**ADDENDUM NUMBER: TWO**

**ISSUED BY: SEPW Architecture Inc.**  
109 – 3725 Pasqua St., Regina, SK. S4S 6W8

**PROJECT: INTERIOR FIT-UP PHASE 2  
REGINA, SASKATCHEWAN**

This Addendum forms part of the Contract Documents and amends the original Drawings and Specifications dated 2017-02-03, previous Addenda if applicable and as noted below. This Addendum consists of **13** pages.

**AR-1**

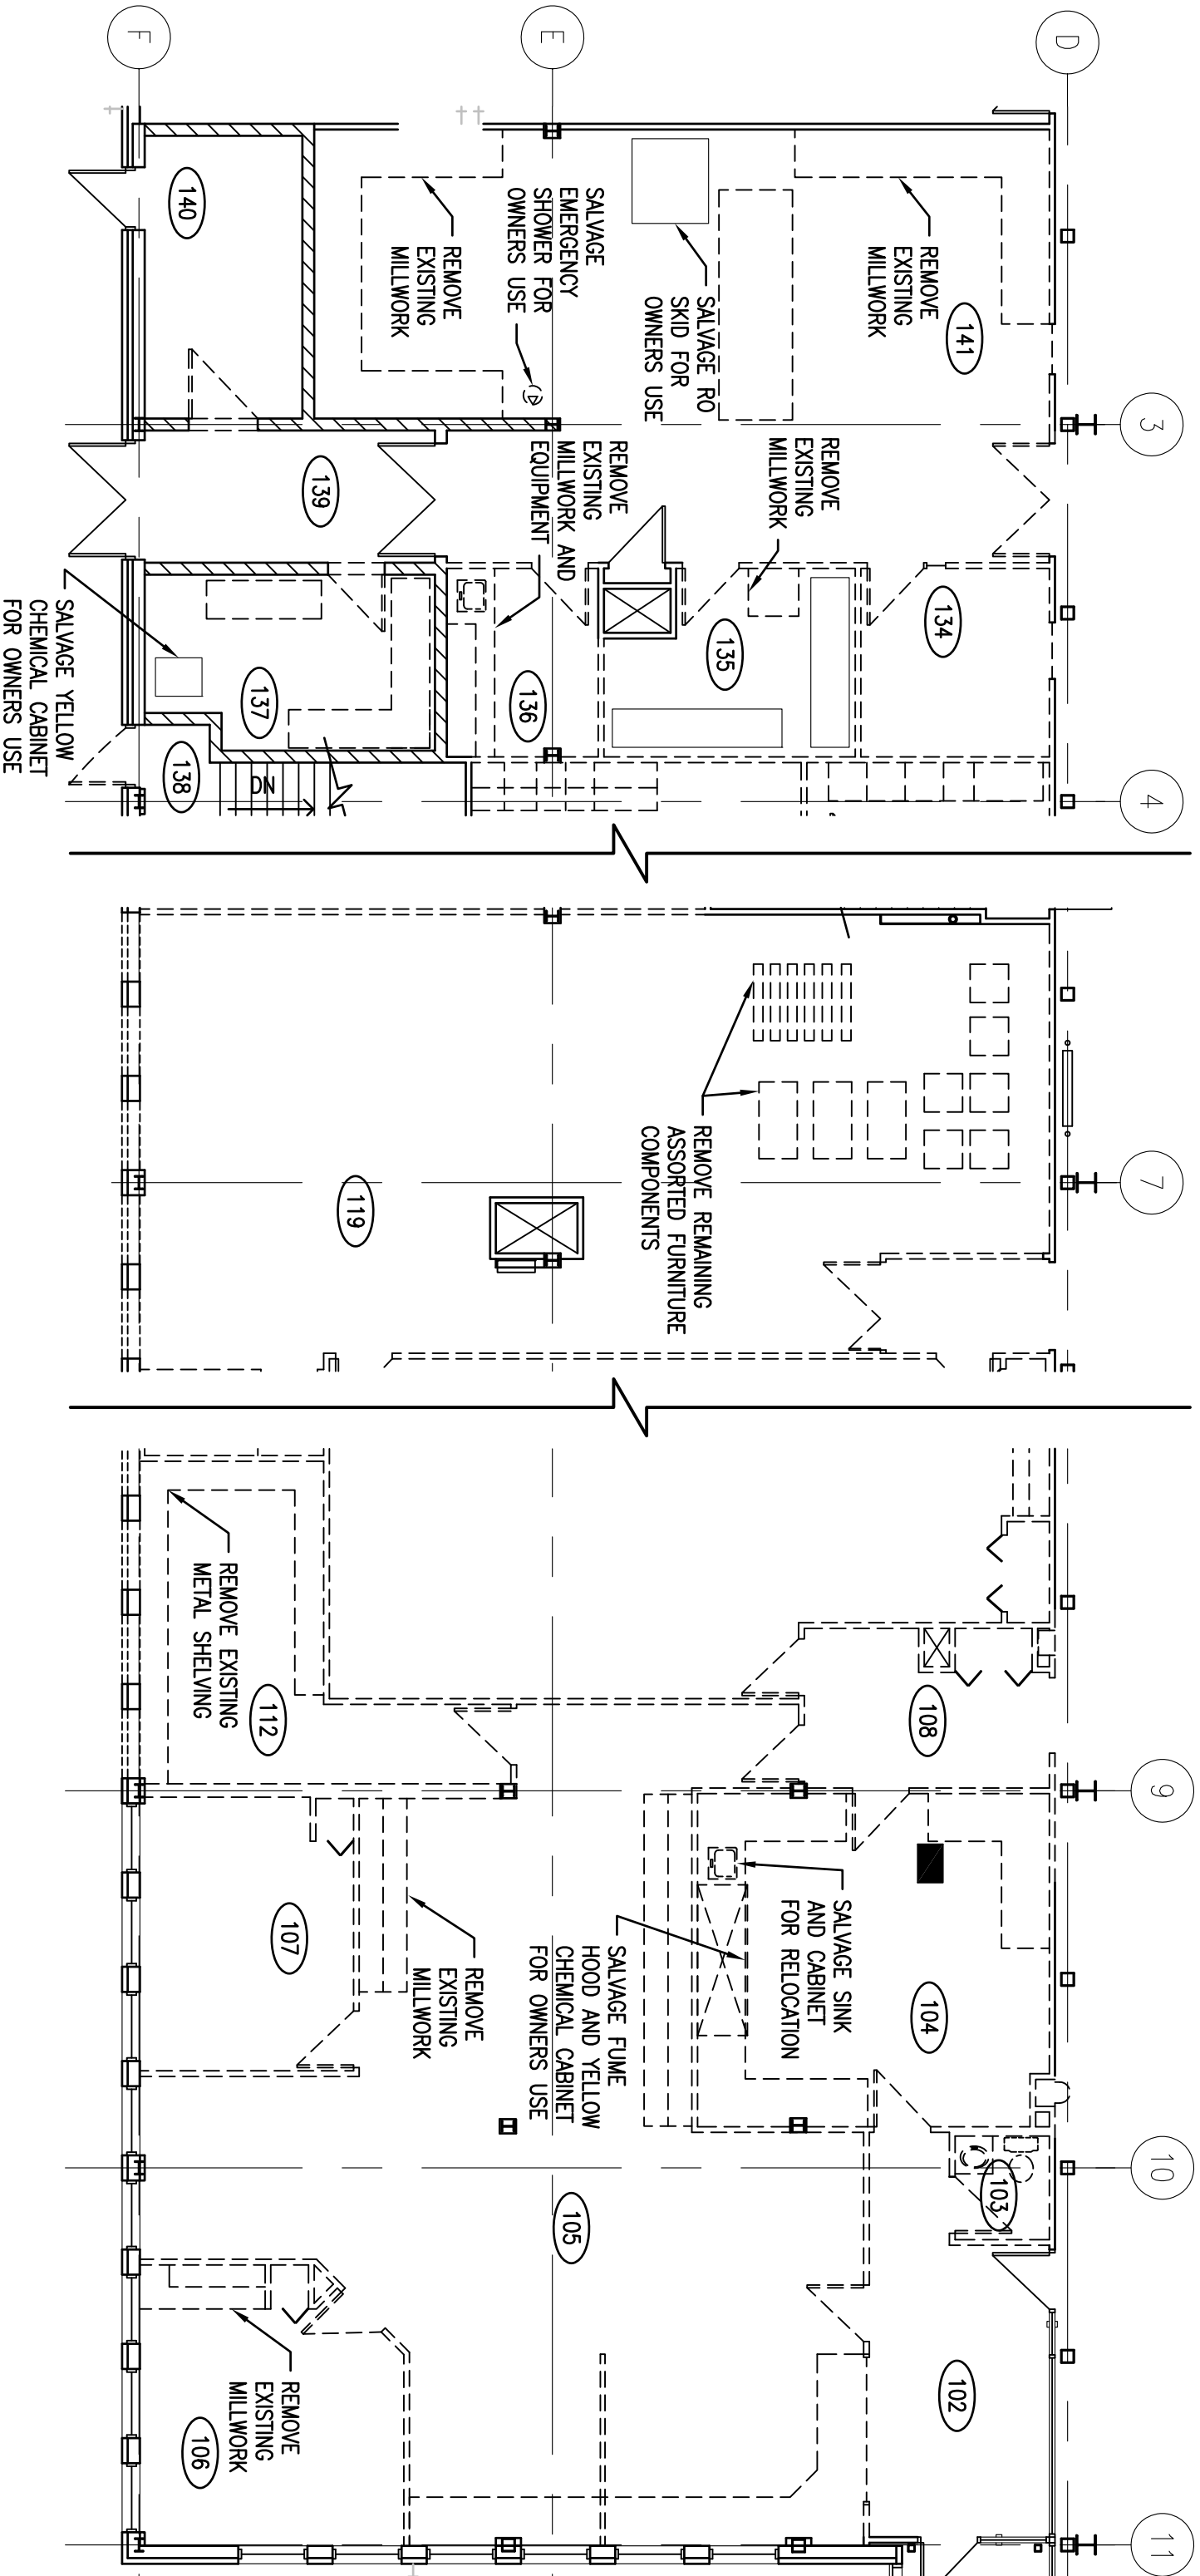
- .2 Reference Room 202: Add note "Provide blocking for 65" monitor on West wall."  
Refer to AR-1 for blocking size and information.
- .3 Reference Room 205: Add note "Provide blocking for 65" monitor on South wall."  
Refer to AR-1 for blocking size and information.
- .4 Reference Room 206: Add note "Provide blocking for 65" monitor on North wall.  
Center line of blocking to be 3000mm west of millwork." Refer to AR-1 for  
blocking size and information.
- .5 Reference Room 217: Add note "Provide blocking for 65" monitor on East wall."  
Refer to AR-1 for blocking size and information.

DRAWING TITLE  
ADDITIONAL DEMOLITION AND SALVAGE EQUIPMENT  
MAIN FLOOR EAST PARTIAL PLAN

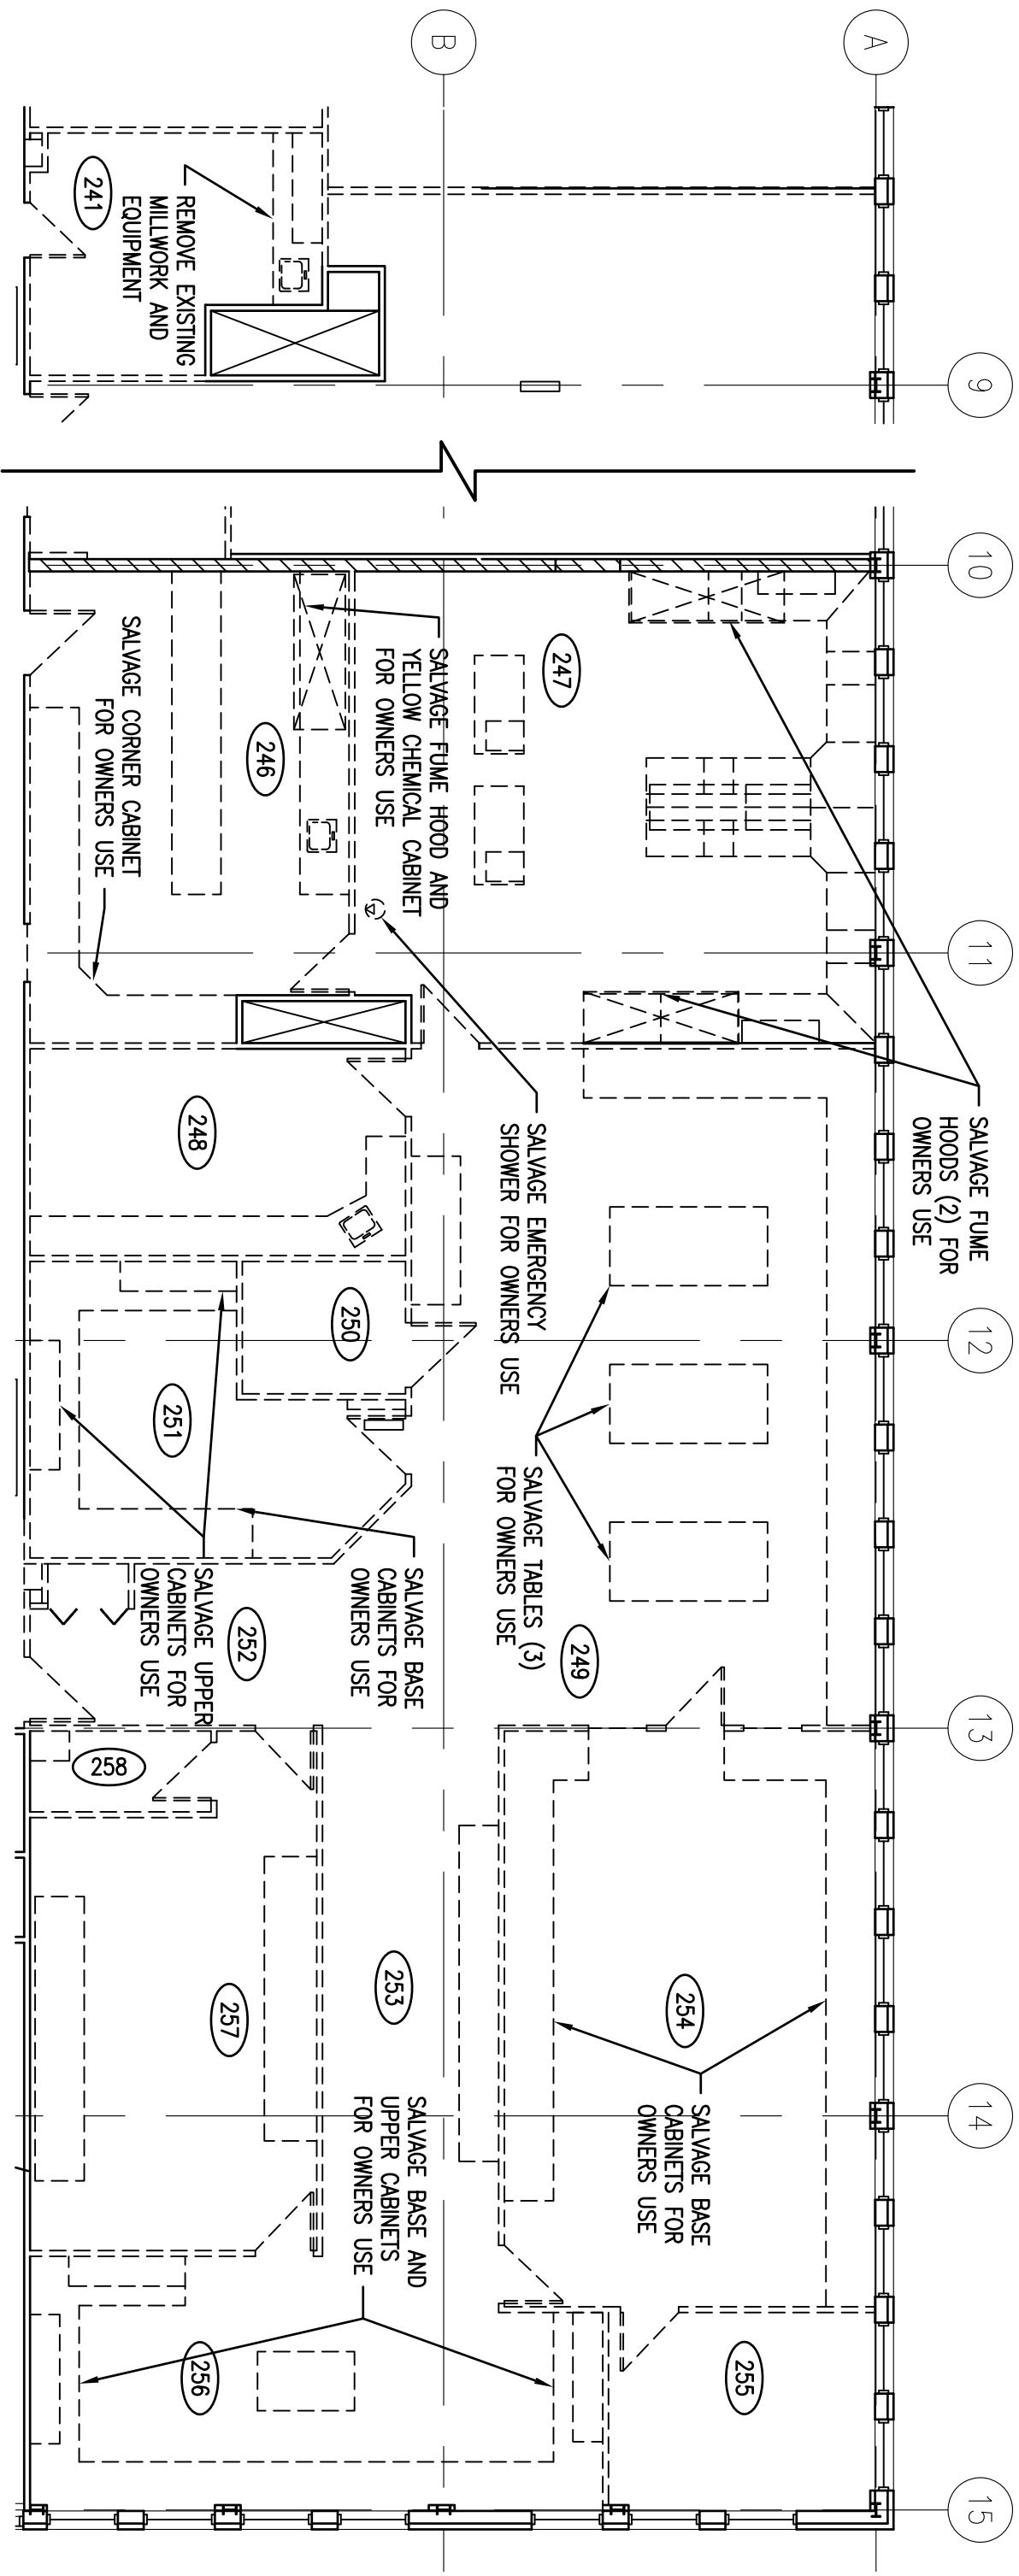
**A-2-13 REF. DRAWING A2.1 DEMOLITION PLAN MAIN FLOOR PLAN EAST  
AND AR-2**

- .1 Refer to sketch AR-2 (Attached to this Addendum) for Additional Demolition and Salvage notes.

A14: *Refer to AR-2 and AR-3 attached to this addendum for updated demolition and salvage locations throughout the building.*

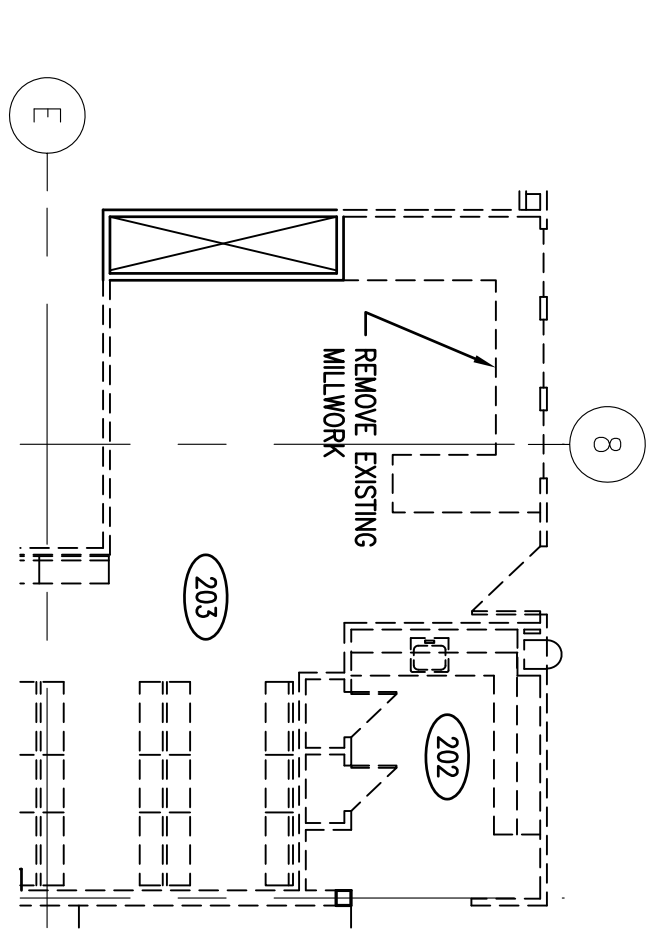
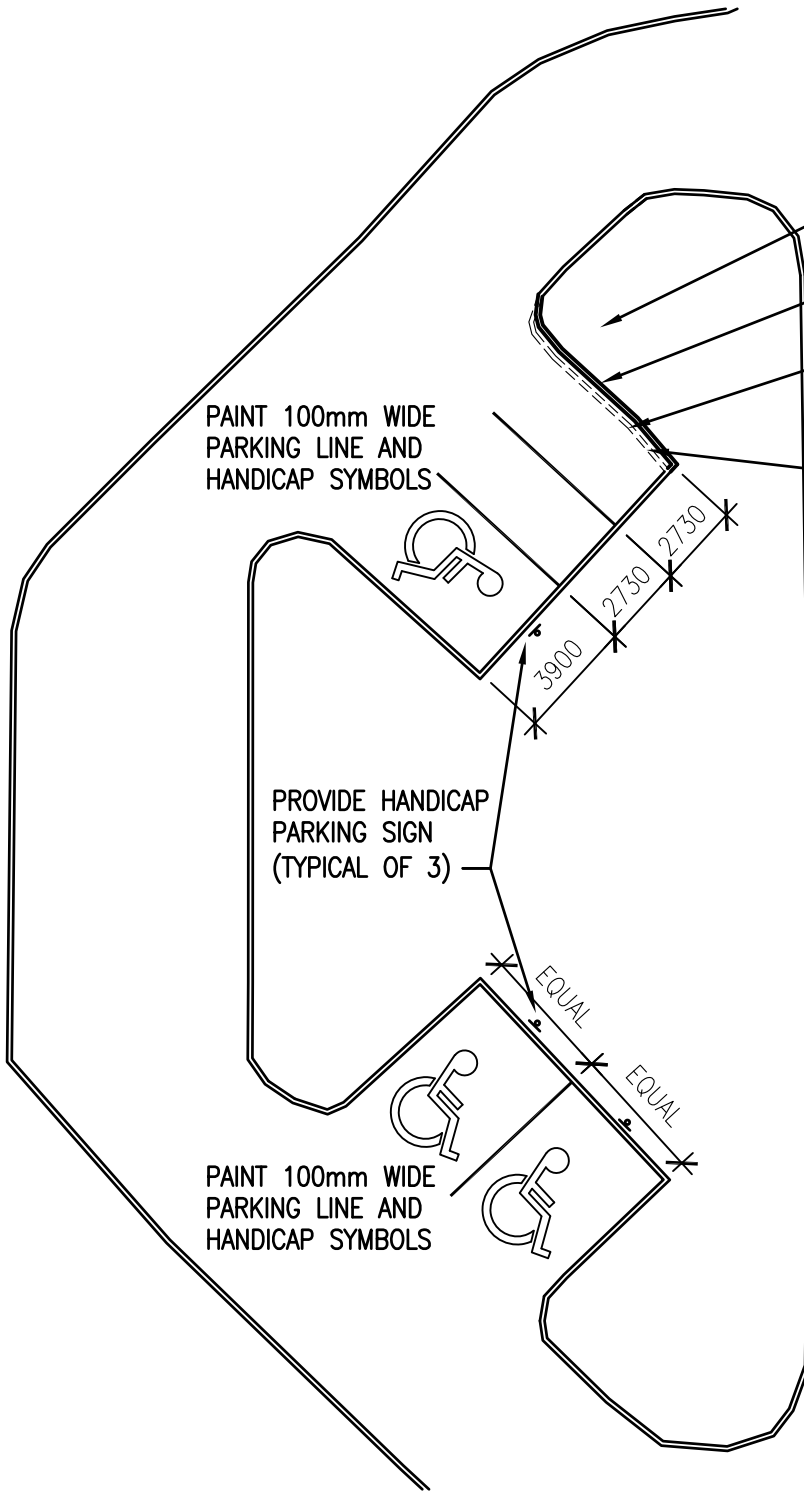
**A-2-14 REF. DRAWING A2.3 DEMOLITION PLAN SECOND FLOOR PLAN EAST  
AND AR-3**

- .1 Refer to sketch AR-3 (Attached to this Addendum) for Additional Demolition and Salvage notes.

DRAWING TITLE  
**PARTIAL BASEMENT PLAN**

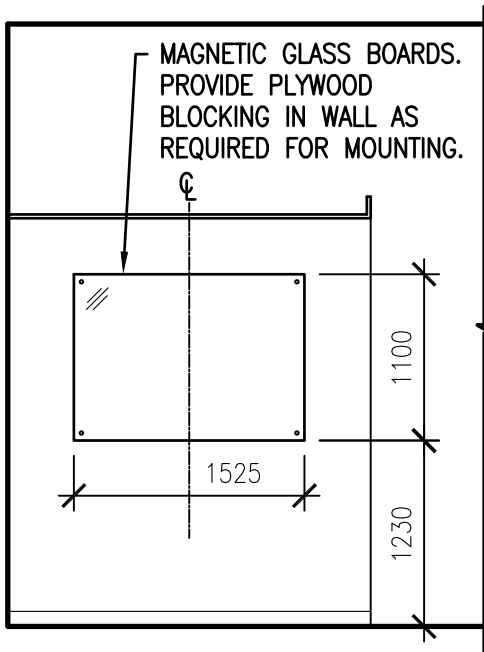
- .1 Remove existing chiller pumps in middle of mechanical room for replacement of  
concrete. Re-install existing chiller pump in same location after concrete  
replacement. See architectural drawings AR-5 (Attached to this Addendum) for  
location of pumps.
